NORTH FALLS

Offshore Wind Farm

Draft Marine Mammal Mitigation Protocol (Tracked~~Clean~~)

Document Reference: 7.7
Volume: 7
Date: May~~rch~~ 2025
Revision: 21

Plate 1.2 Proposed piling mitigation procedures.

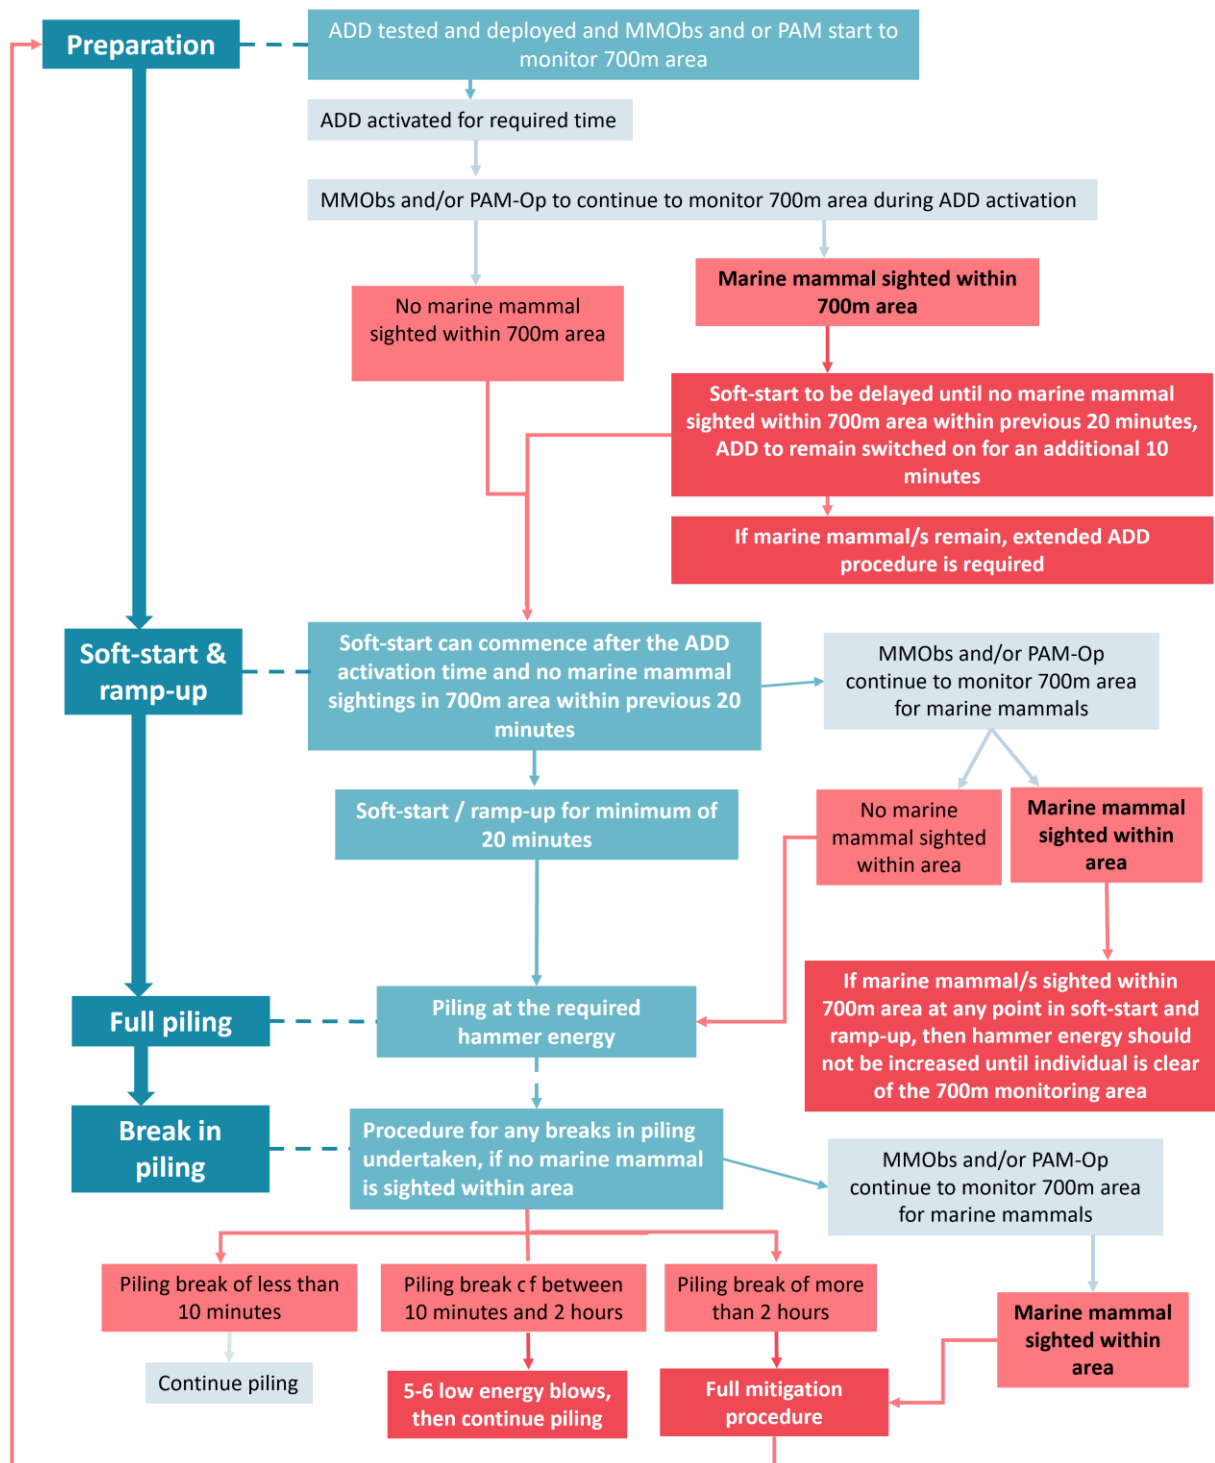
Natural England	E24	Natural England advises that, for clarity and completeness, a separate section on the procedures in the case of marine mammal detections should be included in the MMMP for all possible scenarios. Currently, this information is included under the section '1.3.2.1.1 Marine Mammal Observers' We advise that the Applicant includes a separate section within the MMMP on the procedures that should be followed when marine mammals are detected within the Monitoring Area.	The Applicant has noted Natural England's comment, a separate section summarising procedures for marine mammal detections has been added in Section 1.3.2.5.
Natural England	E25	We note that, for clarity and completeness, it should be clearly stated that "for any breaks in piling of less than 10 minutes, piling may continue as required (i.e. as if there was no break)" as long as no marine mammals have been detected within the Monitoring Area during this time. We advise that the Applicant should add the mention of no marine mammal detections during the breaks in piling within this section.	The Applicant has taken note of Natural England's comment, this has been added into the first bullet point under Section 1.3.2.4.

- If there are marine mammals within the MA, then the full mitigation procedure (~~Plate 1.2~~~~Plate 1.2~~) would be undertaken, including 30 minutes observation of the MA by MMObs and / or PAM, ADD deployment and activation for the required time, followed by the soft-start and ramp-up procedure (for a minimum of 20 minutes).

- For any breaks in piling of more than two hours then the full mitigation procedure (~~Plate 1.2~~~~Plate 1.2~~) is required, including 30 minutes observation of the MA by MMObs and / or PAM, ADD deployment and activation for the required time, followed by the soft-start and ramp-up procedure.

Appendix B. Plots for Comparable Hammer Strike Energies

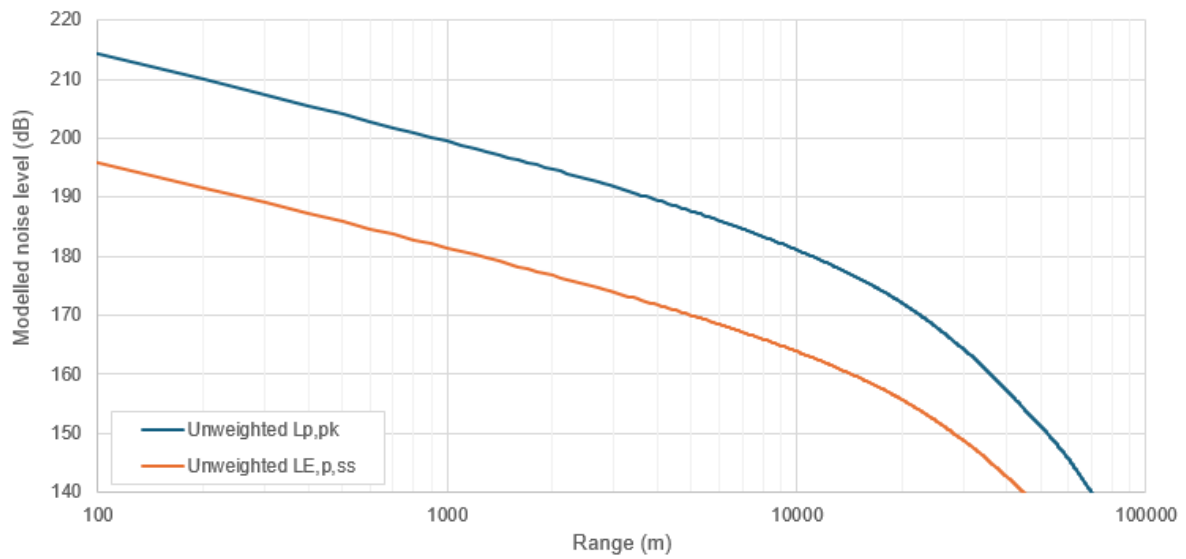
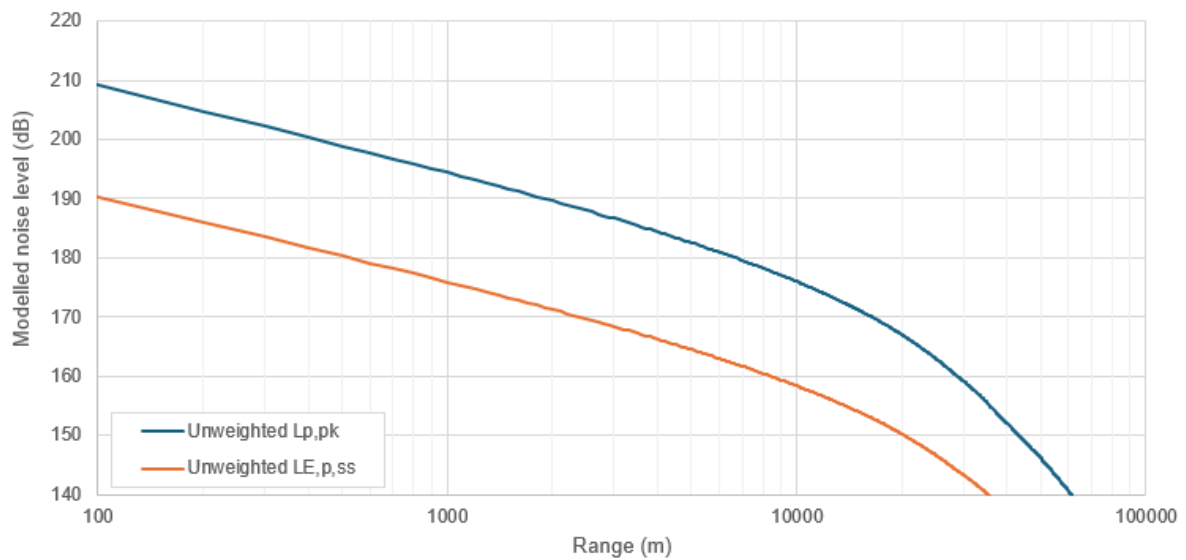
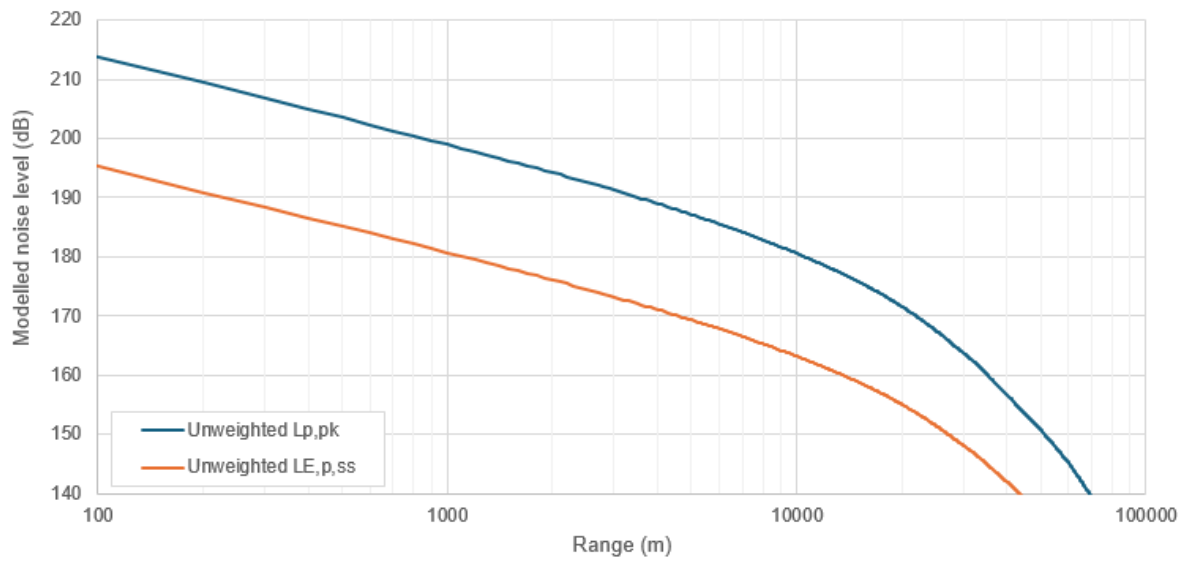
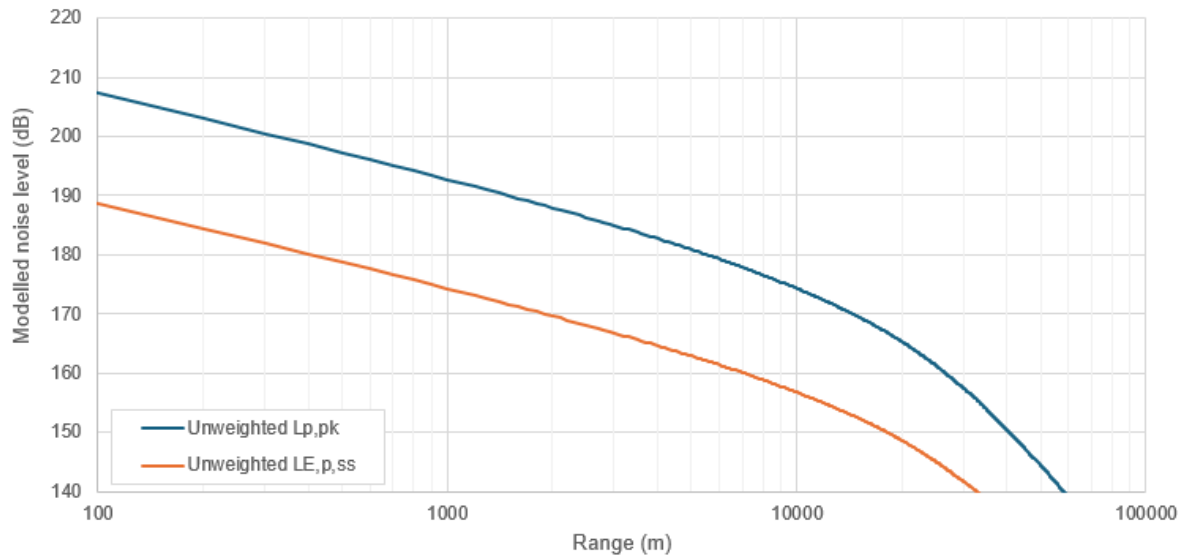
Consultee	Reference	Comment	Response / where addressed in the MMMP
		the final MMMP. The MMO suggests that the Applicant consults with the specific UXO contractor to determine the appropriate parameters for safely deploying bubble curtains. If environmental conditions are not conducive to the use of a bubble curtain, then the MMO recommends postponing any high-order detonations until conditions are suitable.	
MMO	MMO-195	The purpose of the noise monitoring during construction is to determine the actual underwater noise levels on site for comparison with the modelled levels presented in the ES. The MMO acknowledges that the measurements taken during installation will be constrained by various factors such as the piling plan and site limitations and a direct (like-for-like) comparison with a modelled scenario is unlikely to be possible. Nevertheless, even if the piling locations and choice of transects would not be matched precisely, both modelling and monitoring should provide enough information to deduce some envelope of received level curves in each case. Thus, some sort of comparison/s in the form of 'level vs range' plots (for comparable hammer strike energies), with the associated envelopes of variability, should be possible and would be expected. Therefore, the MMO recommends that such a plot is provided.	The Applicant has noted this comment from the MMO, therefore, these plots have been provided in Appendix B as part of the ^{his} revised Draft MMMP (Revision 1).

~~13.~~ This update includes plots of the noise levels at different ranges for the monopiles and pin-piles for the first and maximum hammer strikes included in Appendix B.
